M190077

Response to Requests for Additional Information

Non-Proprietary Information

Figure 1: Time Step Sizes for Table 5-3 Cases

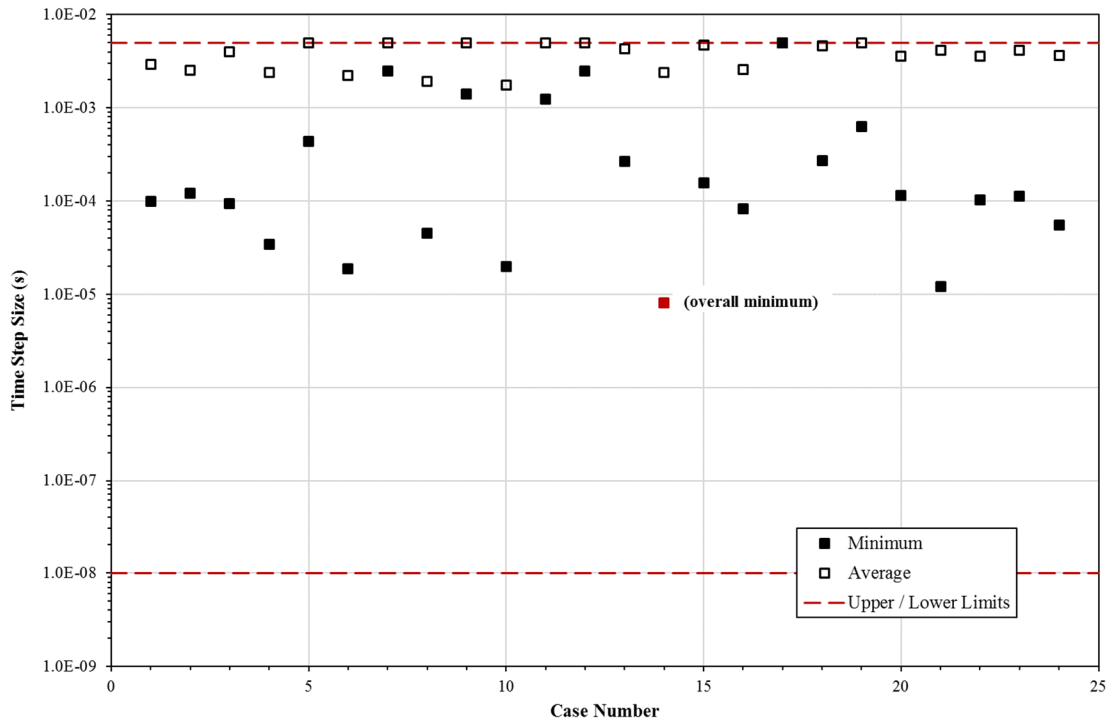
The guidance provided in the TR does not discuss any specific constraints or recommendations that may be necessary for the time step size or explain why the recommended inputs from prior NRC approved applications of TRACG are acceptable for the CRDA event. The CRDA event is a very rapid prompt power excursion that occurs on a very short time scale, so the predicted neutronic response due to heatup of the fuel and moderator may be sensitive to the time step size. Provide a discussion regarding what time step inputs are to be used for the CRDA analysis, and why these inputs are acceptable for this intended application.

Figure 1 presents the minimum and average time step size for each case compared to the minimum and maximum allowable time step size. The minimum time step size actually used was $8.07\text{E-}06$ seconds which is roughly two orders of magnitude from the $1.0\text{E-}08$ second minimum allowable time step size. The average time step size is approximately $3.76\text{E-}03$ seconds. This example demonstrates that the specified lower limit on allowable time step size is sufficiently low that its value will not affect the results.
